MANNIS ADDITION TO SEDGWICK COUNTY, KANSAS

RE: SUB 2001-62 -- One-Step Final Plat of Mannis Addition

RE: SUB 2001-62 -- One-Step Final Plat of Mannis Addition

CASE NUMBER: SUB 2001-62 -- MANNIS ADDITION

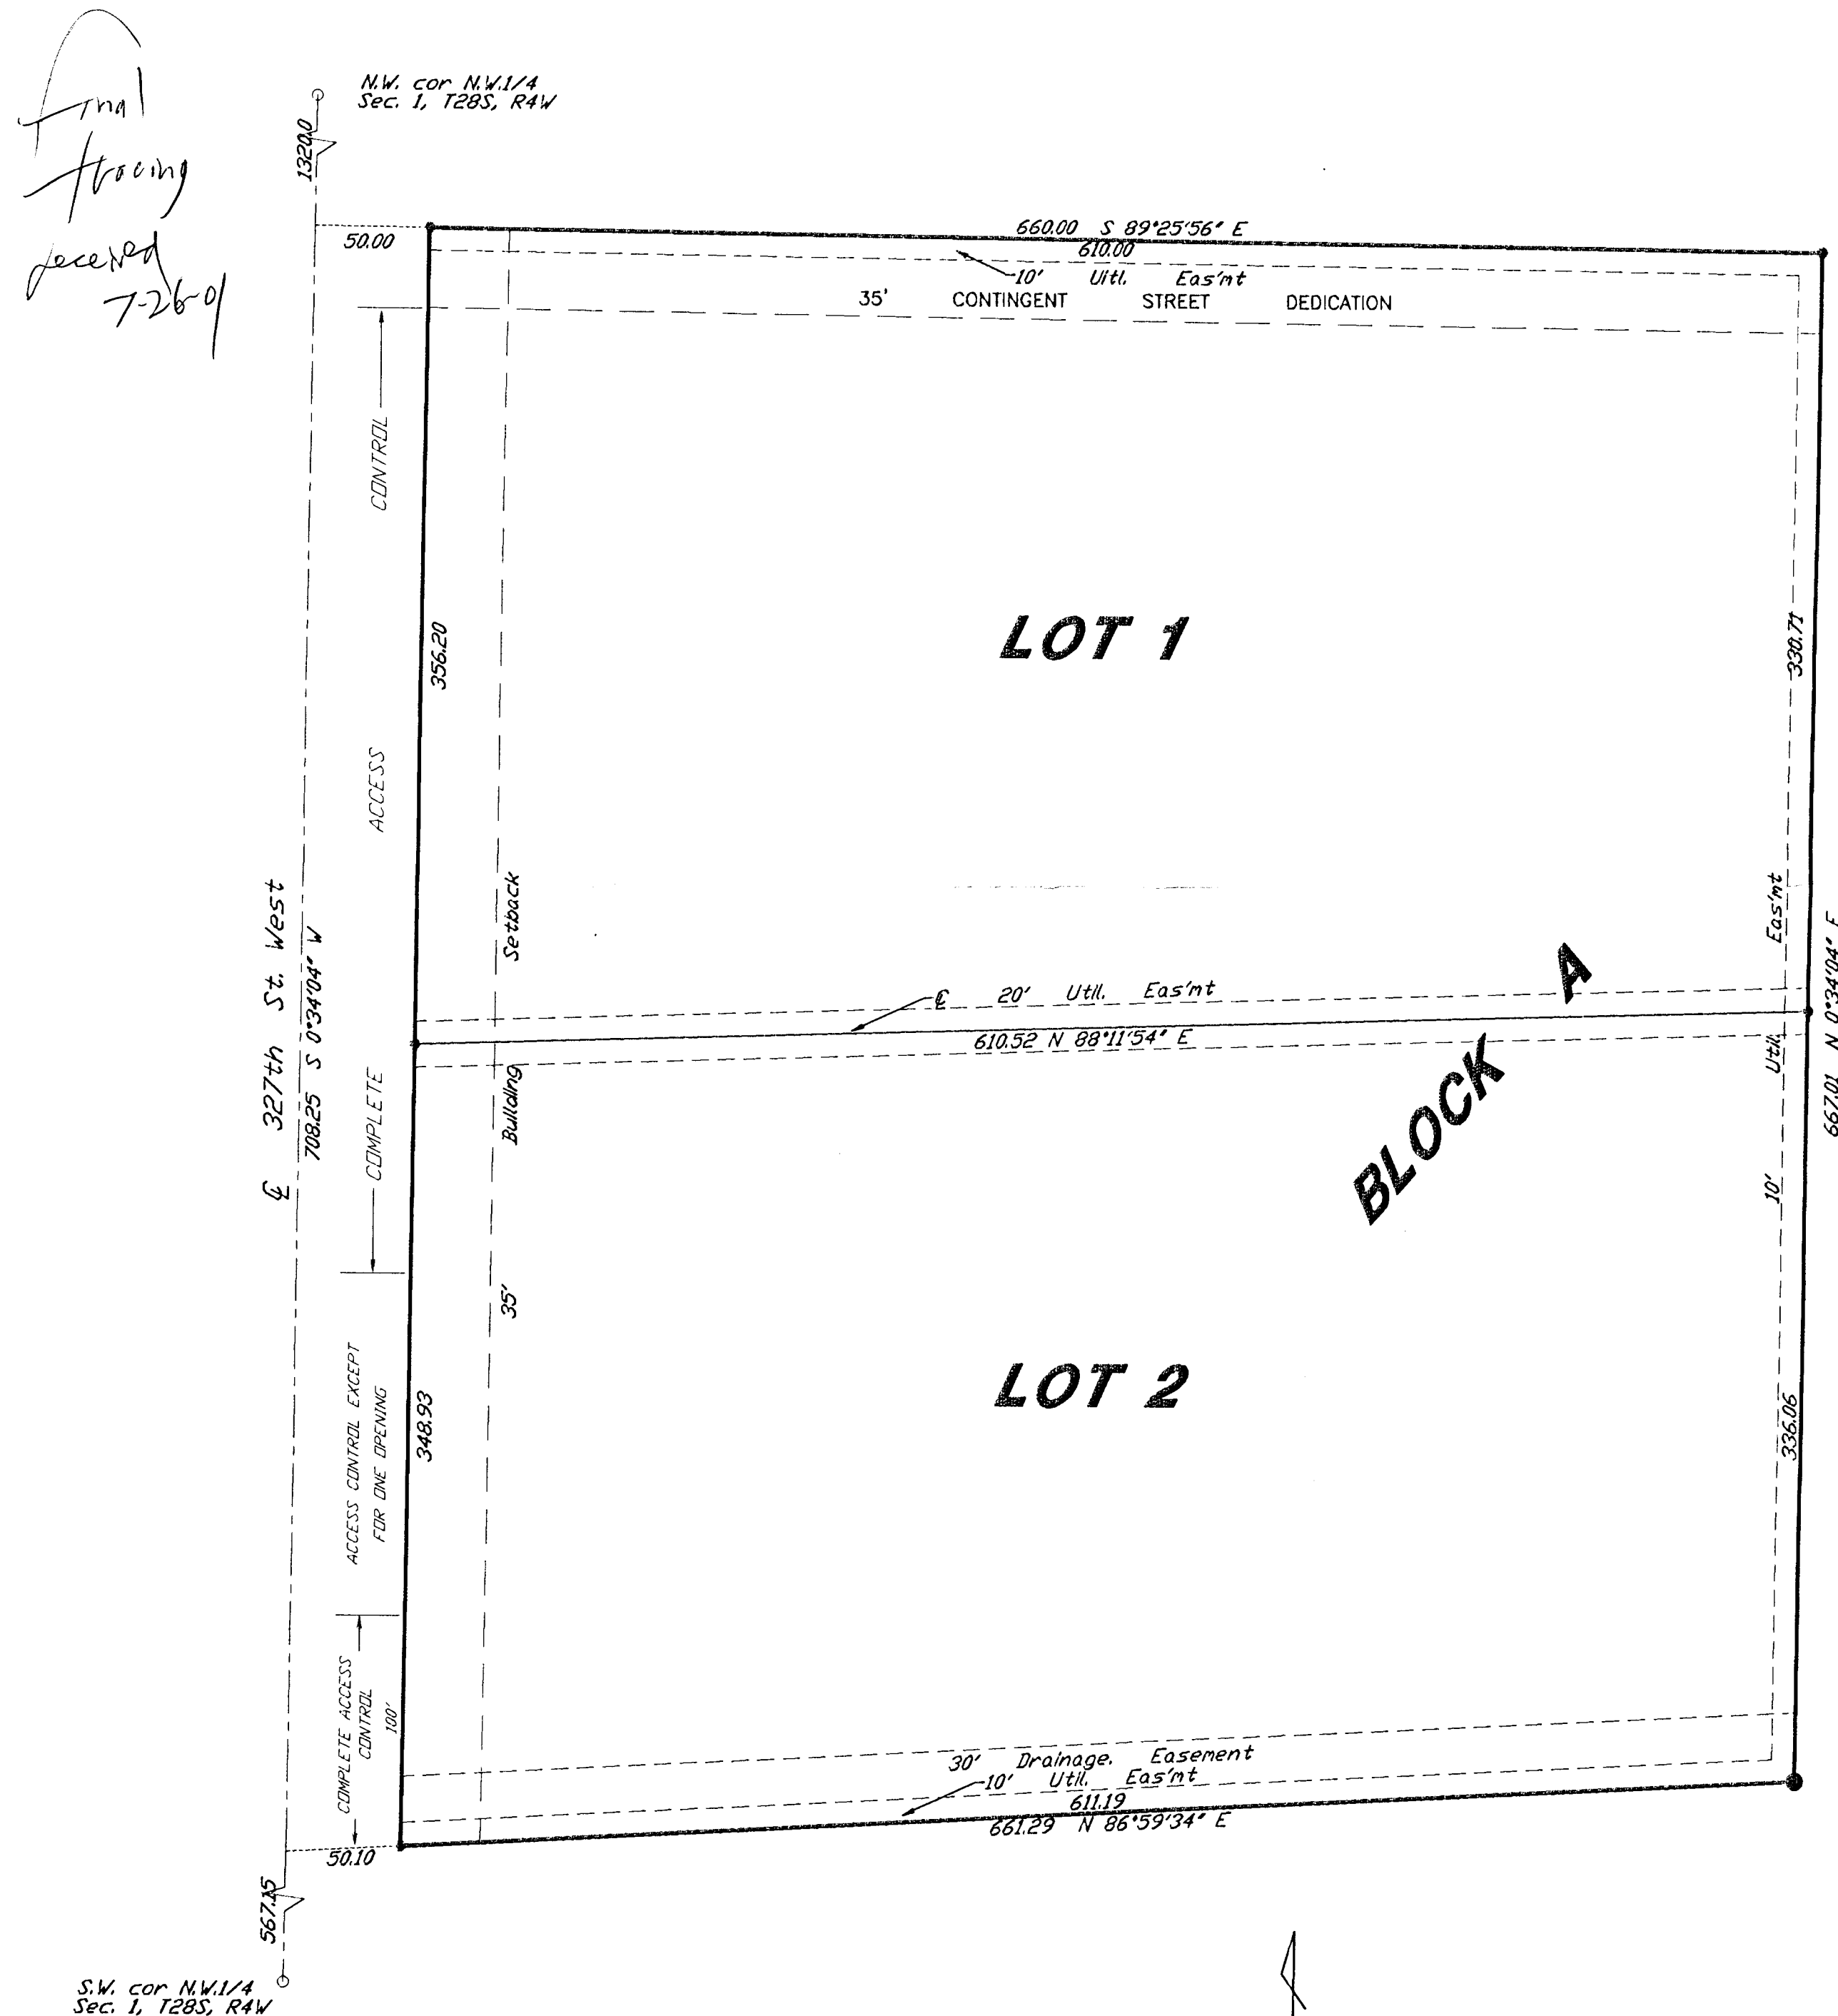
- D. Based upon the legal description shown on the plat, the site involves the land extending to the section line and consequently the 50-ft strip along the west line of the plat would be a dedication of street right-of-way for 327th St. West. Both the face of the plat and the platlor's text shall denote and reference such dedication.

- E. County Engineering needs to comment on the access controls and the need for a joint access opening. The plat proposes one access opening per lot. County Engineering has approved one opening per lot. The opening for Lot 1 shall be in alignment with the contingent street right-of-way. The opening for Lot 2 shall be located along the northern portion of the lot.

- F. The platlor's text should include the reference to 327th St. West in regards to access controls.
- G. The face of the plat should designate a block number or letter, as is referenced in the platlor's text.

- H. On the final plat, the MAPC signature block needs to reference "J.D. Michaelis, Acting Chair".
- I. The signature line for the County Commissioners Chair needs to reference "Carolyn McGinn".

- J. The Applicant shall plat a 35-ft contingent street right-of-way along the north property line of Lot 1 for future connection to adjoining properties. The contingent street dedication shall be referenced in the platlor's text.

- K. The Applicant is advised that if platted, the building setbacks must be 35 feet to conform with the Zoning setback standard for County section line roads.

- O. The applicant's engineer is advised that the Register of Deeds is requiring the name(s) of the notary public, who acknowledges the signatures on this plat, to be printed beneath the notary's signature.
